***30691-4 OY3 #3 December 2023 / Building 2 / 1st Floor / 1st Floor Bldg 2.**

***30691-4 OY3 #3 December 2023 / Building 2 / 2nd Floor / 2nd Floor Bldg 2. (2nd Floor Bldg 2)**

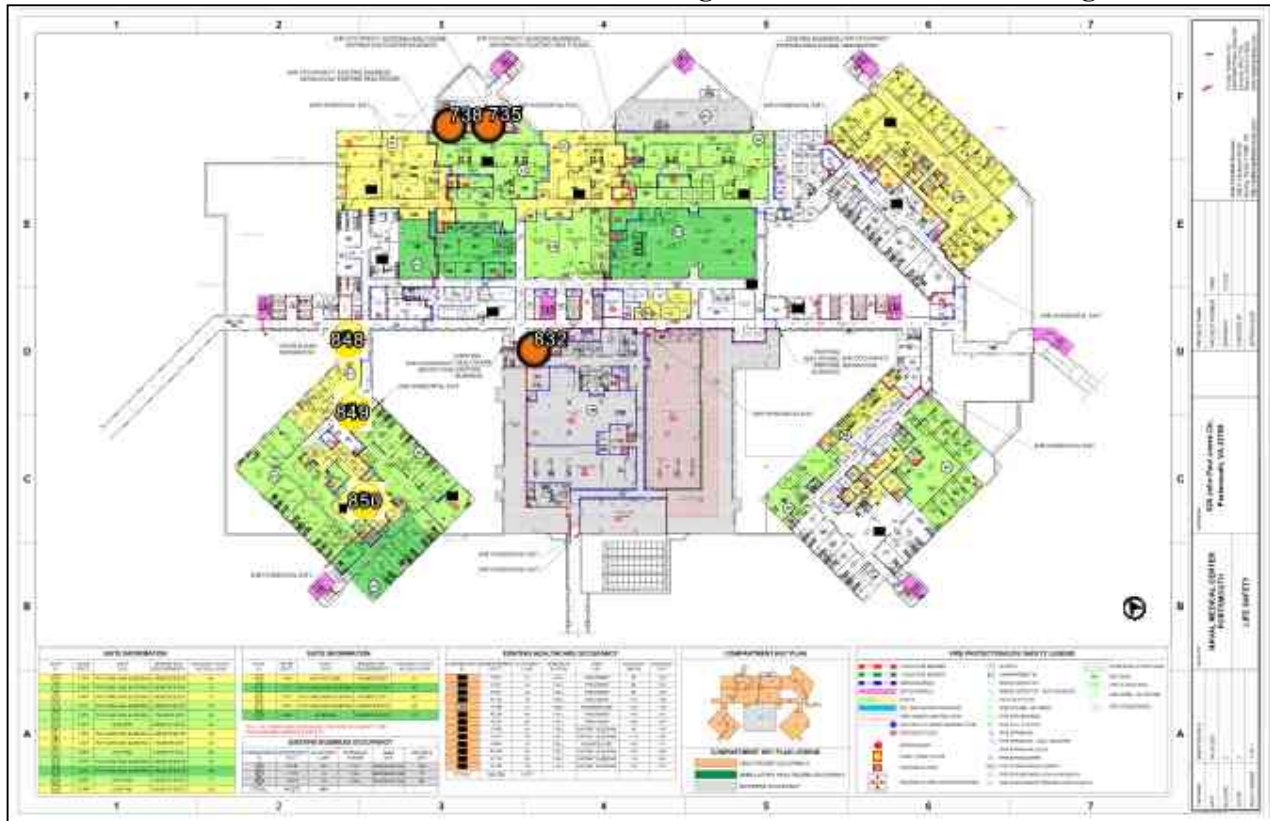
Icon	Punch #	ID	Room Number	System	Inspection Type	Item	Type	Fire Rating	Wall Material	Action	Resource	Comments	Due	Type Comment	Created By	Priority
	1713	885619		cja1080	Repairs	TP-Wall	Metallic Pipe	1 Hour Smoke Zone Barrier	Concrete	Repair			12/14/23		MS	
Repair 12/14/23 12/23/23 NFPA 101 Section 8.5 Room Number 110103 12/14/23 12/23/23 Wall Direction 12/14/23 12/23/23 East Lineal Feet 12/14/23 12/23/23 Repair 12/14/23 12/23/23 NFPA 101 Section 8.5

2333	887412		hwd0236	Repairs	TP-Wall	Blank Opening	1 Hour Smoke Zone Barrier	Gypsum	Repair			2/19/24		MS	
Repair 2/19/24 2/19/24 NFPA 101 Section 8.5 Room Number 134243 2/19/24 2/19/24 Wall Direction 2/19/24 2/19/24 south Lineal Feet 2/19/24 2/19/24 Repair 2/19/24 2/19/24 NFPA 101 Section 8.5

*30691-4 OY3 #3 December 2023 / Building 2 / 3rd Floor / 3rd Floor Bldg 2

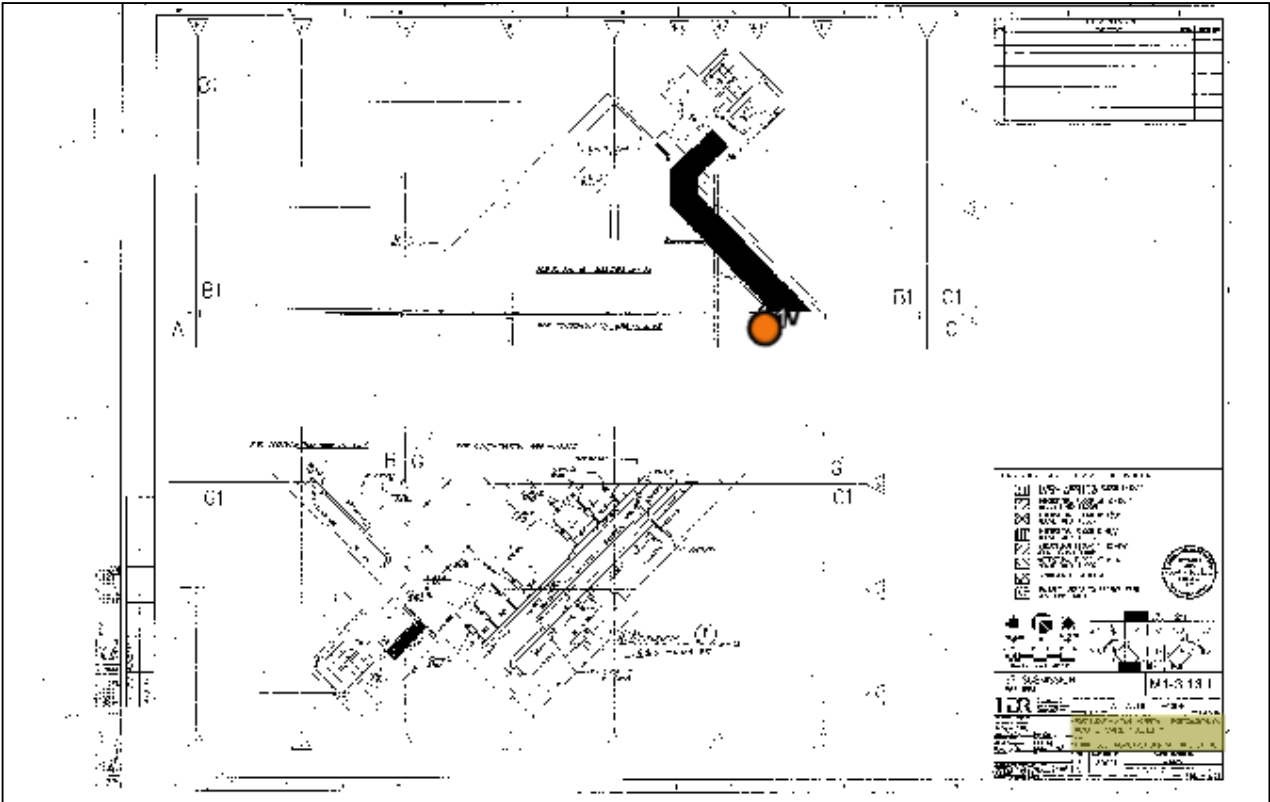
Icon	Punch #	ID	Room Number	System	Inspection Type	Item	Type	Fire Rating	Wall Material	Action	Resource	Comments	Due	Type Comment	Created By	Priority
	735	885627		caj1080	Repairs	TP-Wall	Metallic Pipe	1 Hour Smoke Zone Barrier	Concrete	Repair			12/14/23		MS	
	Repair 12/14/23 12/23/23 NFPA 101 Section 8.5 Room Number st43n 12/14/23 12/23/23 Wall Direction 12/14/23 12/23/23 West Lineal Feet 12/14/23 12/23/23 Repair 12/14/23 12/23/23 NFPA 101 Section 8.5

738	885630		wl0034	Repairs	TP-Wall	Blank Opening	2 Hour	Concrete	Repair			12/14/23		MS	
	Repair 12/14/23 12/20/23 NFPA 101 Section 8.5 Room Number 323402 12/14/23 12/20/23 Wall Direction 12/14/23 12/20/23 North Lineal Feet 12/14/23 12/20/23 Repair 12/14/23 12/20/23 NFPA 101 Section 8.5

Icon	Punch #	ID	Room Number	System	Inspection Type	Item	Type	Fire Rating	Wall Material	Action	Resource	Comments	Due	Type Comment	Created By	Priority
	832	886205		w1049	Repairs	TP-Wall	Metallic Pipe	1 Hour Smoke Zone Barrier	Gypsum	Repair			2/14/24		MS	
			Repair	2/14/24	2/14/24	NFPA 101 Section 8.5										
			Room Number	320412	2/14/24	2/14/24										
			Wall Direction	2/14/24	2/14/24	south										
			Lineal Feet	2/14/24	2/14/24											
			Repair	2/14/24	2/14/24	NFPA 101 Section 8.5										
	848	886251			Area	Area Survey	Construction Area			Note			2/14/24		MS	
			Note	2/14/24	2/14/24											
			Wall Direction	2/14/24												
			Room Number	2/14/24												
	849	886252			Area	Area Survey	Construction Area			Note			2/14/24		MS	
			Note	2/14/24	2/14/24											
			Wall Direction	2/14/24												
			Room Number	2/14/24												
	350	886253			Area	Area Survey	Construction Area			Note			2/14/24		MS

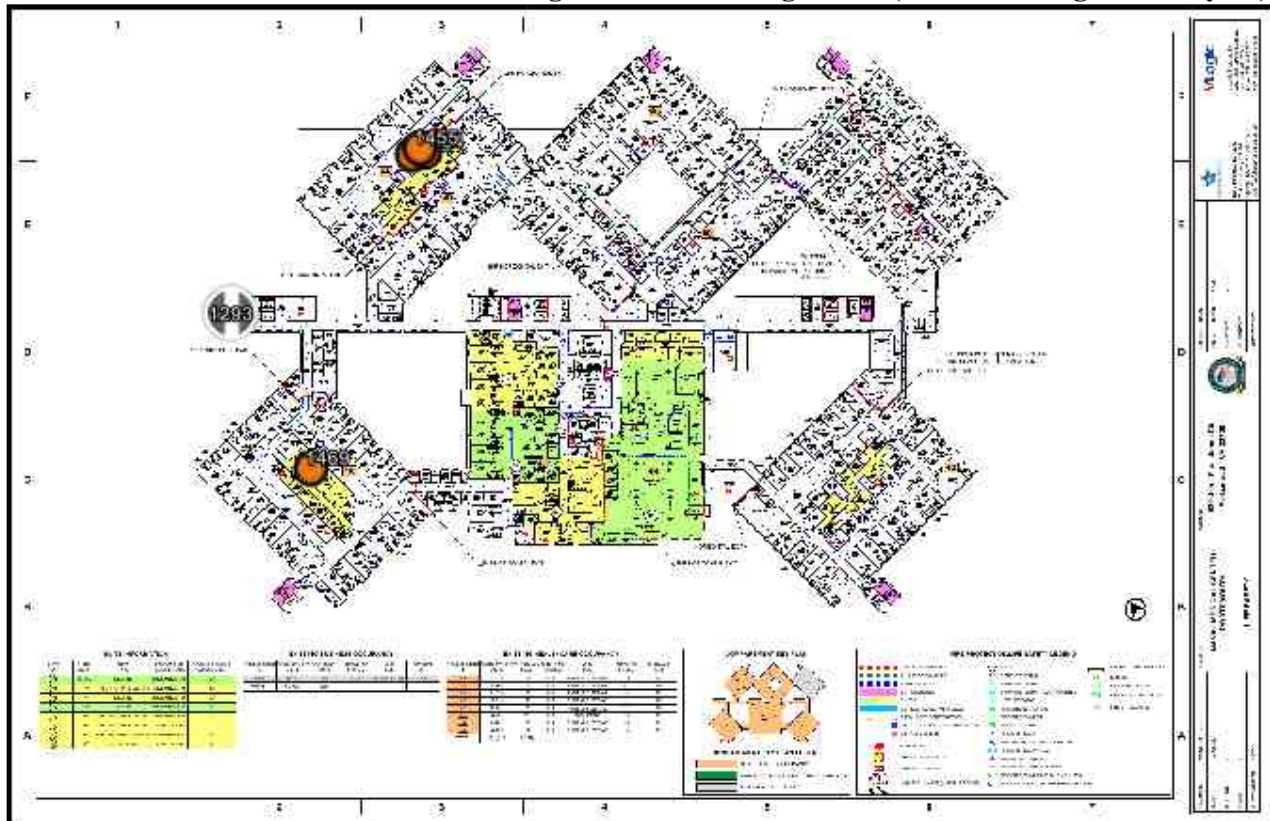
Icon	Punch #	ID	Room Number	System	Inspection Type	Item	Type	Fire Rating	Wall Material	Action	Resource	Comments	Due	Type Comment	Created By	Priority
		885634			Repairs	TP-Wall	Cable Tray		Gypsum	Repair			12/14/23		MS	
Repair12/14/23NFPA 101 Section 8.5 Room Number12/14/23 Wall Direction12/14/23 Lineal Feet12/14/23 Repair12/14/23NFPA 101 Section 8.5

*30691-4 OY3 #3 December 2023 / Building 2 / 4th Floor Bldg 2 RFS (4th Floor Bldg 2 RFS layers)

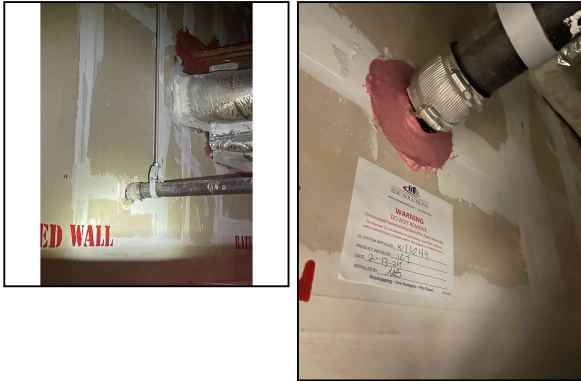
Icon	Punch #	ID	Room Number	System	Inspection Type	Item	Type	Fire Rating	Wall Material	Action	Resource	Comments	Due	Type Comment	Created By	Priority
	1293	885966			Large Opening	Large Opening	Sections of walls missing		Gypsum	Repair			2/13/24		MS	
	Repair	2/13/24			NFPA 101 Section 8.5											
	Room Number	st14	2/13/24													
	Wall Direction	2/13/24			East											
	Lineal Feet	2/13/24														
	Repair	2/13/24			NFPA 101 Section 8.5

1302	885983		w1049	Repairs	TP-Wall	Metallic Pipe	1 Hour Smoke Zone Barrier	Gypsum	Complete			2/13/24		MS	
	Repair	2/13/24			2/13/24	NFPA 101 Section 8.5										
	Room Number	420604	2/13/24		2/13/24											
	Room Number	2/13/24														
	Wall Direction	2/13/24			2/13/24	west										
	Lineal Feet	2/13/24			2/13/24											
	Repair	2/13/24			2/13/24	NFPA 101 Section 8.5
